1 Products affected

Product Change Notification						FIO plastic material change		
owner	creation date	release date	released by	change order no	rev	page	D10-007-252	
zbindeja	2016-08-11	2016-10-07	nowakfr	2010727	Α	1 of 2

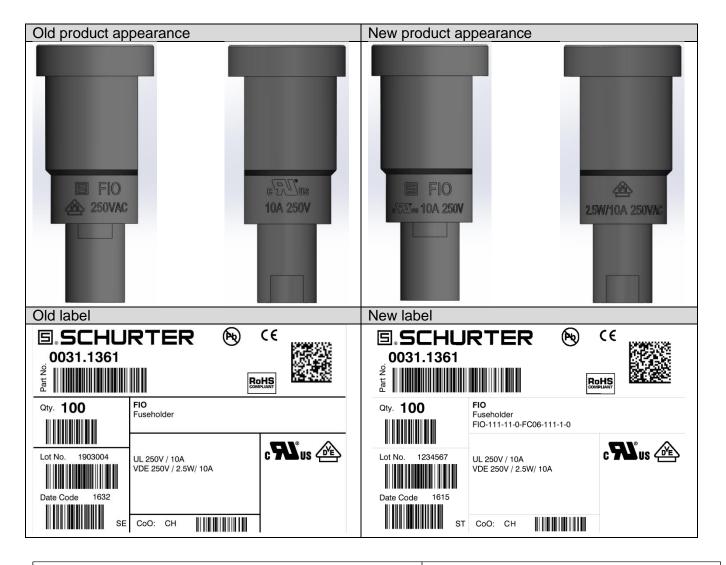
- Change of material
- Modified marks
- Modified label

- Product improvement to fulfil the enhanced glow wire requirements according to the updated standard IEC 60127-6 and the standard IEC 60335-1 for appliances in unattended use.
- Recertification by VDE

Form	Yes	Change of plastic material, modified marking on product
Fit	No	No change for dimension
Function	No	No change in function
manufacturing	No	No change of manufacturing site
Label	Yes	Configuration code added
Packaging	No	No change in packaging
